111th session

Regulation No. 107 (M₂ and M₃ vehicles)

Proposal for amendments to Regulation No. 107 (M₂ and M₃ vehicles)

Submitted by the expert Germany*

4. Example of an integrating sphere according to CIE 38:1977:

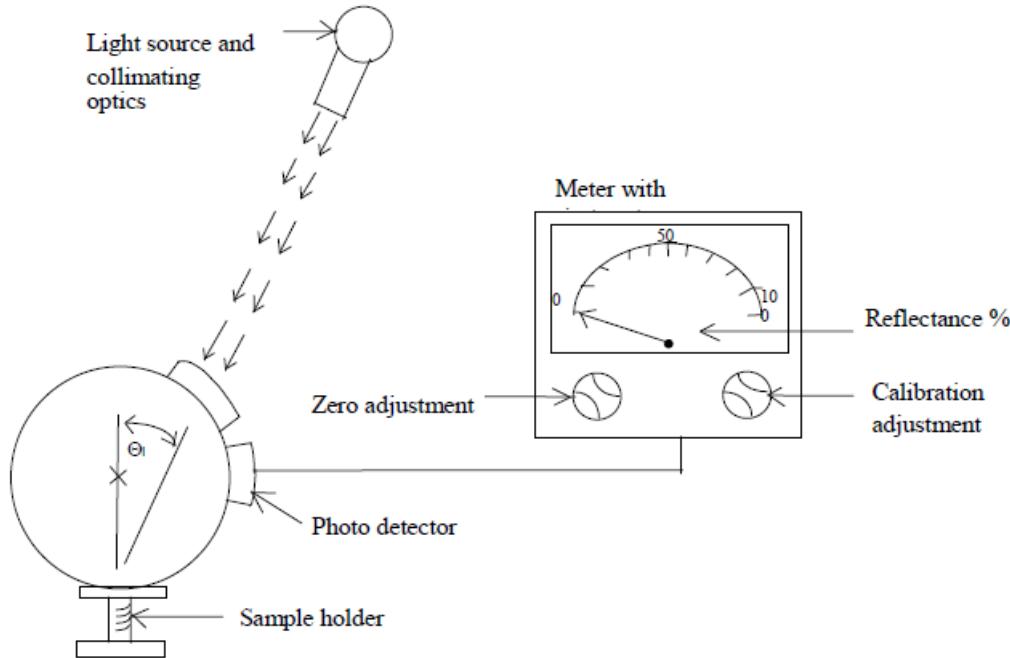
2. For determination of the reflectance values ρ_1 , ρ_2 and ρ_d an integrating sphere according to CIE 38:1977 shall be used.

The reflectance shall be either read directly from the indicating instrument or calculated according to the following formula:

- 2.1. The illumination angle of the luminous flux of the incident light on the sample Θ_i shall be equal to $8^\circ \pm 0.5^\circ$.

- 2.2. The luminous flux of the incident light on the sample shall be determined by using a diffuse reflectance standard calibrated by an accredited laboratory. The extended measurement uncertainty shall be lower than 3 per cent.
